UNITED STATES  
DEPARTMENT OF THE INTERIOR  
BUREAU OF LAND MANAGEMENT

FORM APPROVED  
OMB NO. 1004-0137  
Expires: January 31, 2018**SUNDRY NOTICES AND REPORTS ON WELLS**  
**Do not use this form for proposals to drill or to re-enter an abandoned well. Use form 3160-3 (APD) for such proposals.**5. Lease Serial No.  
NMNM030482

7. If Unit or CA/Agreement, Name and/or No.  
89100850108. Well Name and No.  
INDIAN HILLS UNIT 539. API Well No.  
30-015-32875-00-S110. Field and Pool or Exploratory Area  
INDIAN BASIN-UPPER PENN ASSOC11. County or Parish, State  
EDDY COUNTY, NM**SUBMIT IN TRIPLICATE - Other instructions on page 2**

OXY USA WTP LP - Proposed  
Indian Hills Unit #53  
API No. 30-015-32875

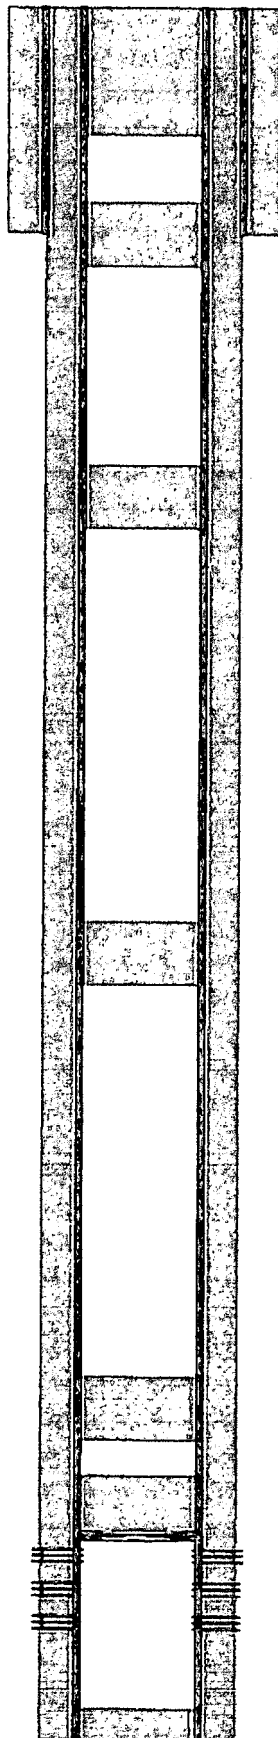
GC 11/20/19  
Accepted for record - NMOCD7004-6826 (WC & ABO) Add Plug: 6190-6030  
WOC Tag (DVT)**SEE ATTACHED FOR  
CONDITIONS OF APPROVAL**
